# River Knoll

## Draft Environmental Impact Statement

To: Ching Wah Chin, Chairman,  
and the Town of Ossining Planning Board

The subject proposed DEIS was reviewed against the Final Scope (the “Scope”) for the Draft Environmental Impact Statement dated July 20, 2016 adopted by the Town of Ossining Planning Board as Lead Agency. We performed the review for the purpose of determining whether the document is complete with respect to scope and content.

Alternative E.b—Townhouses with  
Existing Multi-Family Zone  
**Figure 5-6**

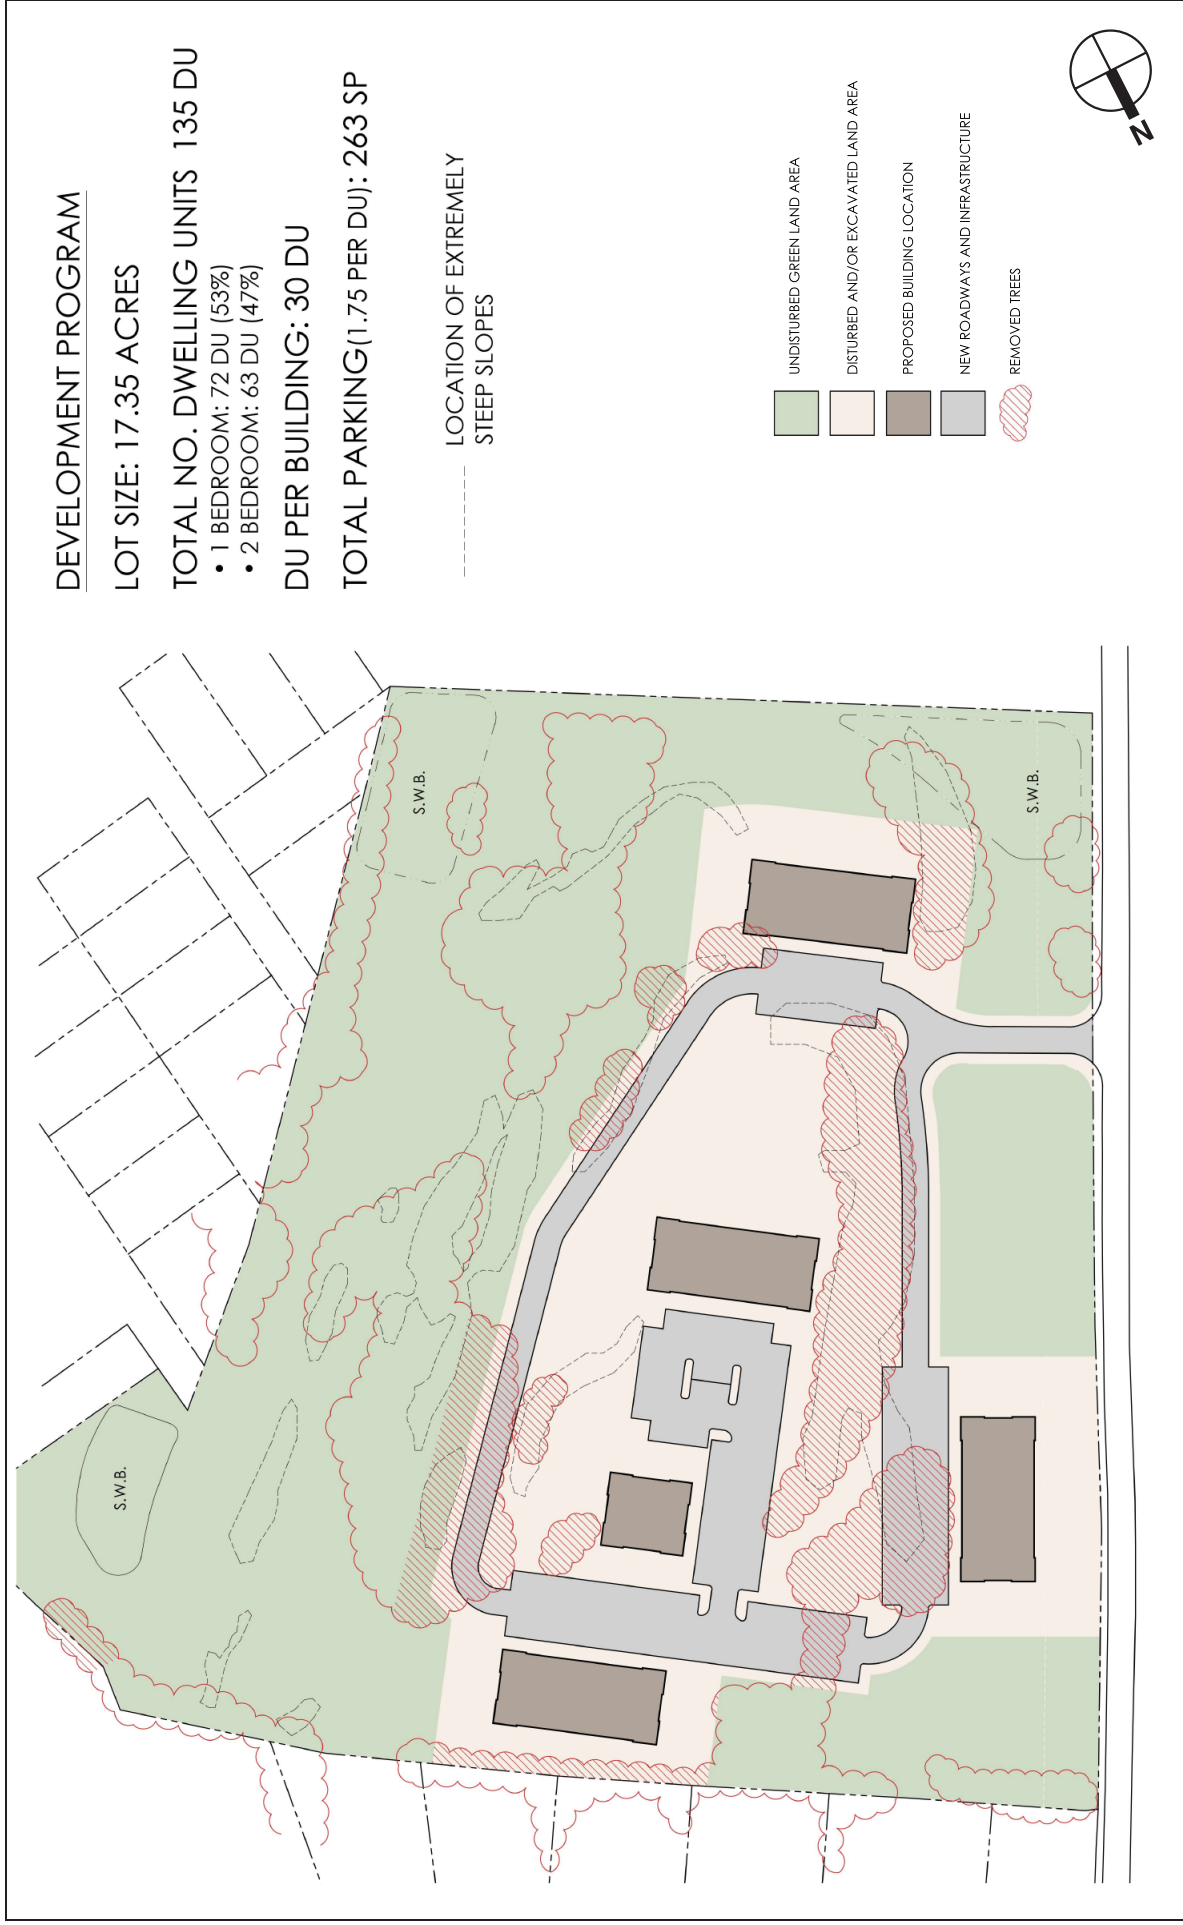
66. Entire Chapter 5, Alternatives: Each of the alternatives required by the Scope must be depicted graphically on plans, otherwise the section is incomplete. There should be a full-sized

73. Site plans for each of the alternatives required by the Scope should be provided. (*Scope Chapter V) Site Plans for six of the eleven alternatives are provided within the revised DEIS.*
